# MORGAN AND MORECAMBE OFFSHORE WIND FARMS: TRANSMISSION ASSETS

Applicants' Response to Secretary of State's Letter Dated 20 May 2026

Document Reference: S\_SoSQ\_14

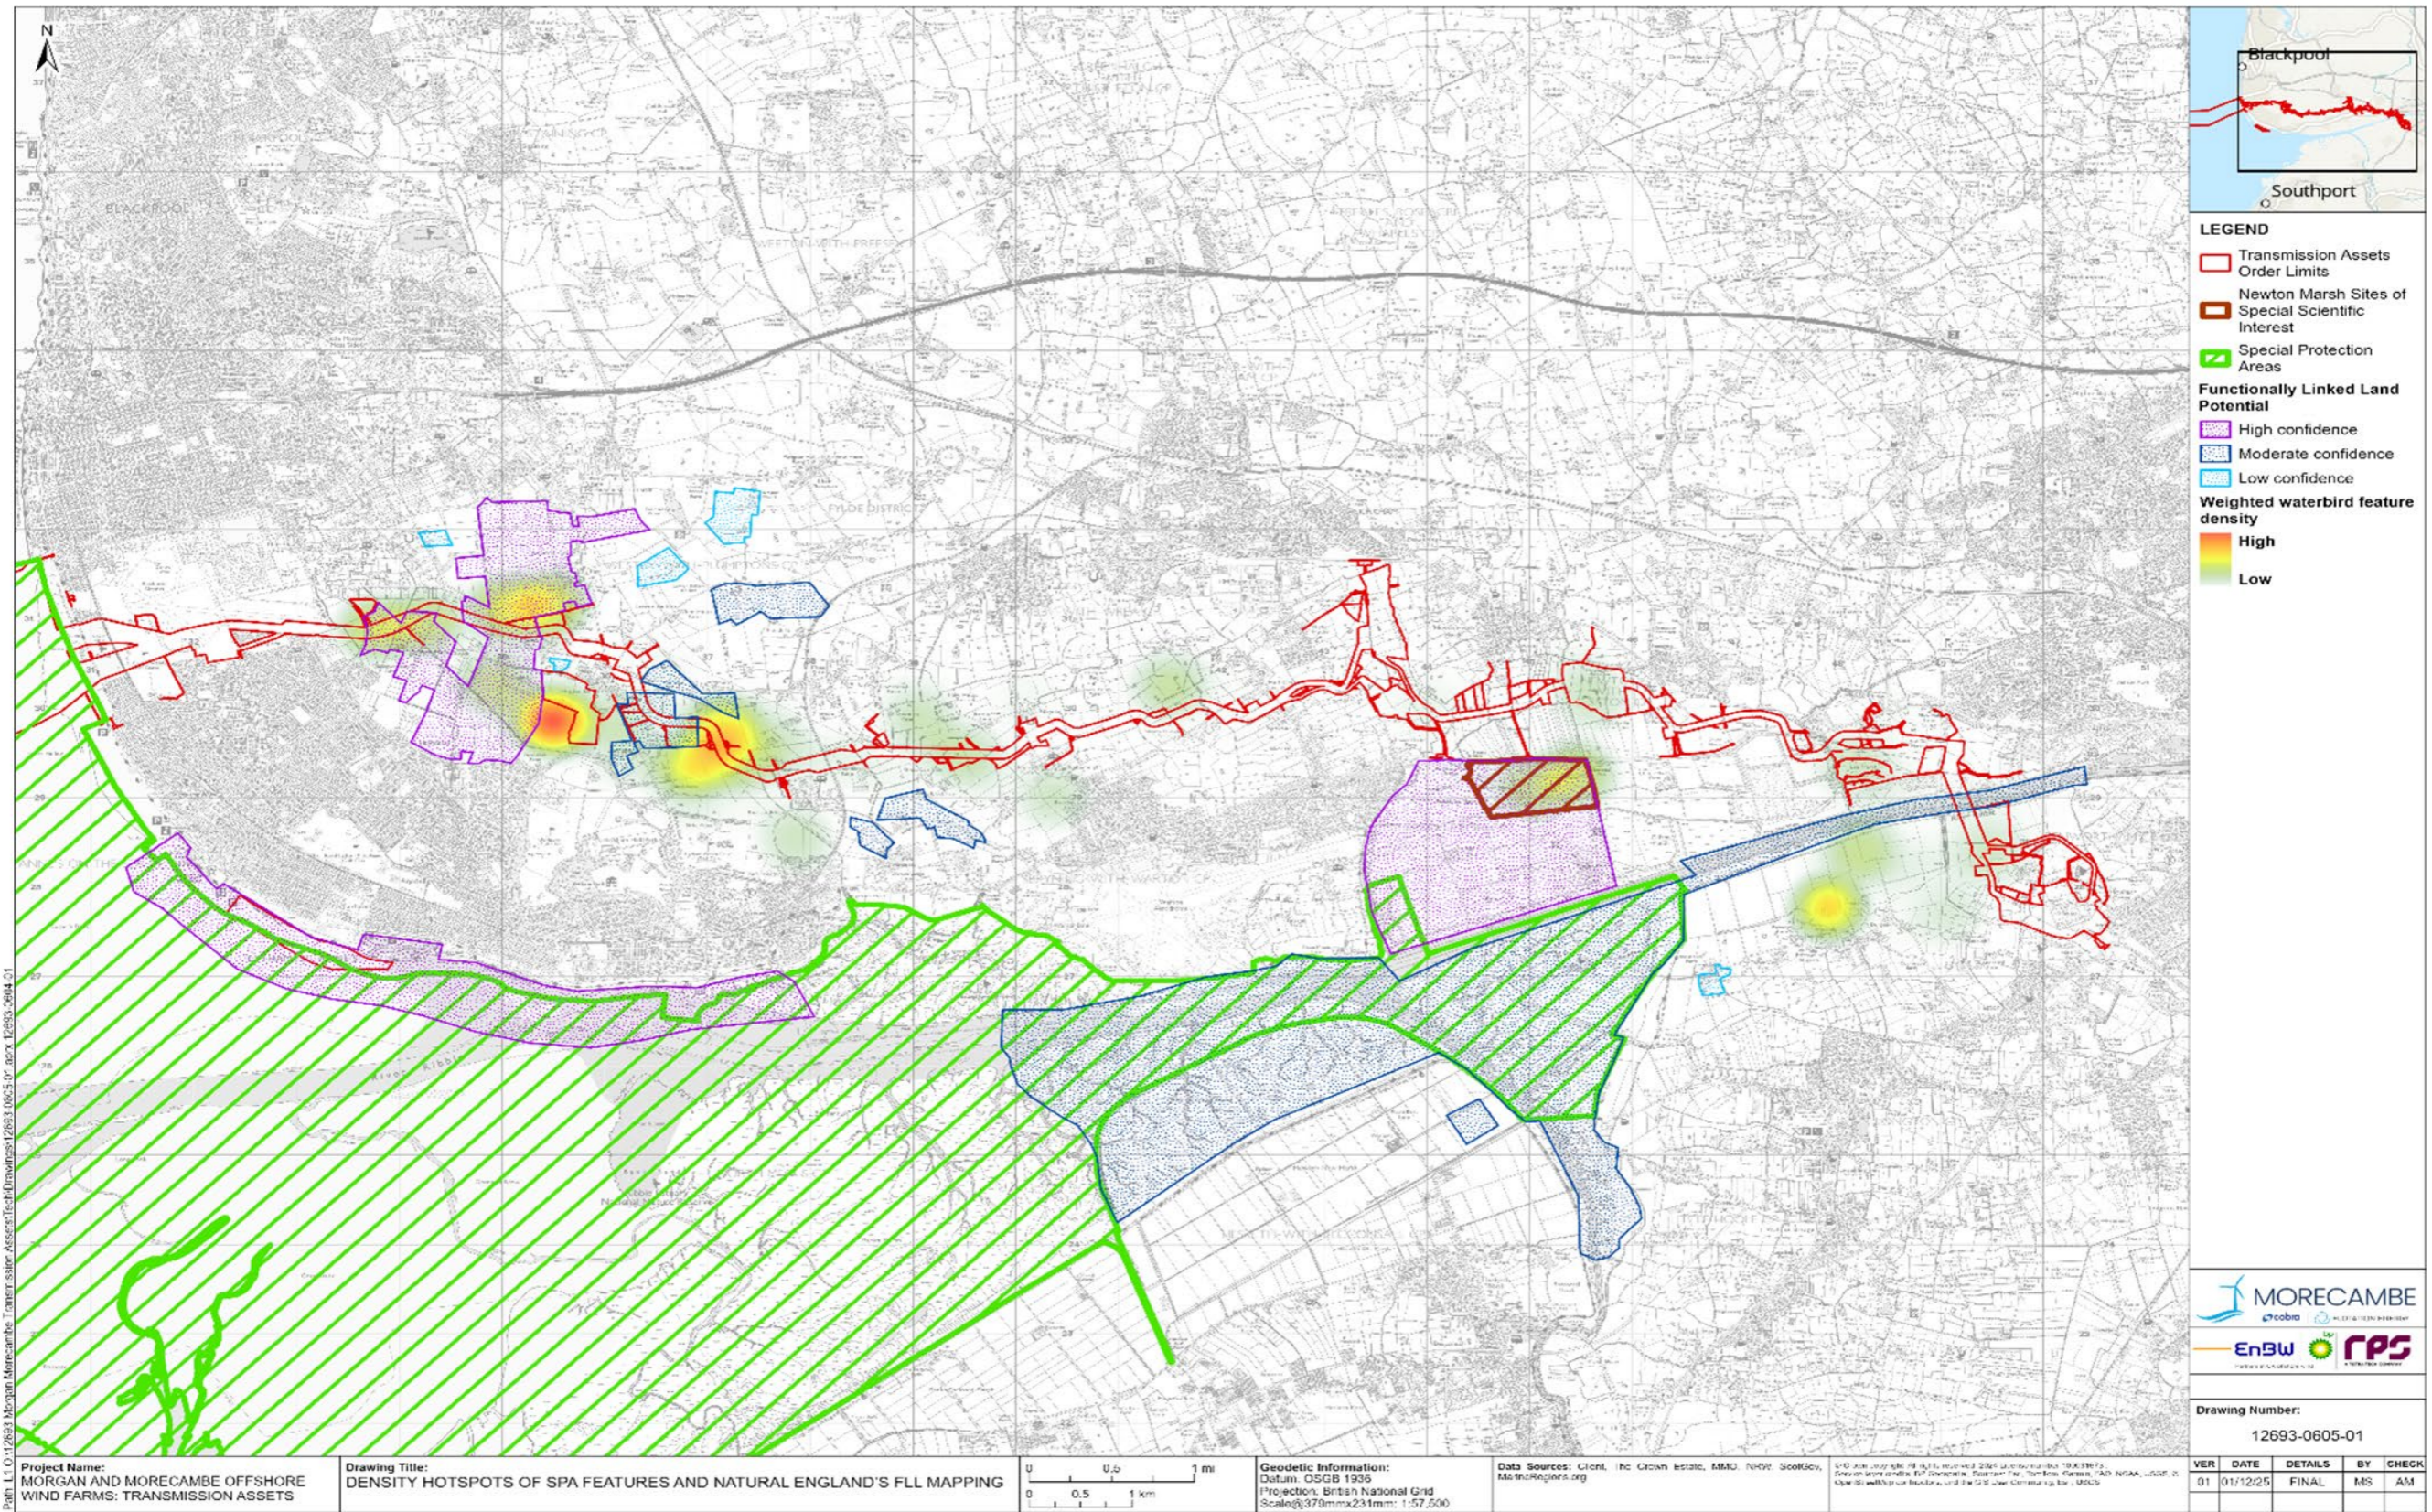
- 
- 1.3.2.28 A summary of these data was presented in the Alternative Ornithology Mitigation Note - Temporary (S\_SoSQ\_5) and is reproduced below in **Figure 1.1** to demonstrate where high abundances of birds were regularly recorded using the same survey methods as employed at the substation sites. **Figure 1.1** demonstrates the likely presence of FLL at Lytham Moss, Newton Marsh SSSI and in the arable fields to the south of the Ribble. This largely coincides with the findings from a Natural England commissioned report to identify FLL in the area ((Bowland Ecology, 2021) (the “Bowland Ecology Report”). See **Figure 1.1**).
